PRODUCT SAFETY WARNING AND RECALL NOTICE

REMINGTON MODEL 700™ AND MODEL SEVEN™ RIFLES

PRODUCTS: Remington Arms Company, LLC (“Remington”) is voluntarily recalling Remington Model 700™ and Model Seven™ rifles with X-Mark Pro® (“XMP®”) triggers, manufactured from May 1, 2006 to April 9, 2014.

PHOTO 3

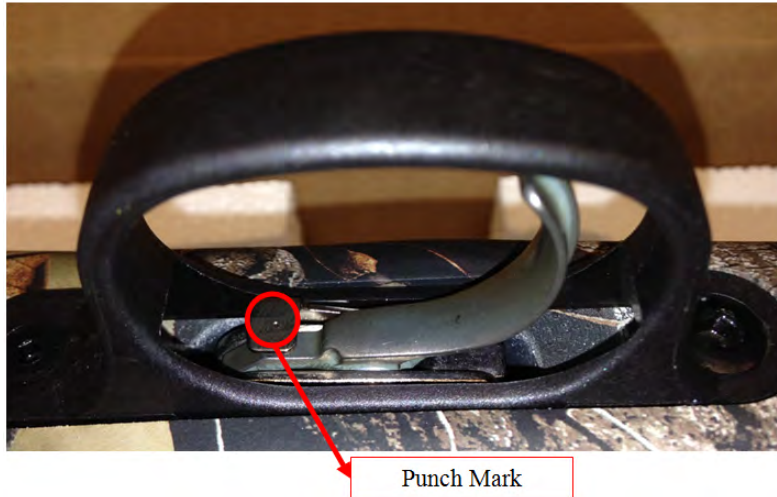
VERIFICATION OF CORRECTIVE ACTION: Upon return of your rifle, you will note a punch mark on the bolt release (see Photo 3 below). This mark confirms your rifle has been inspected and specialty cleaned under this recall program.

Remington has also corrected the XMP trigger assembly process to eliminate this problem in rifles made after April 9, 2014. Rifles made after April 9, 2014 will also have a punch mark on the bolt release.
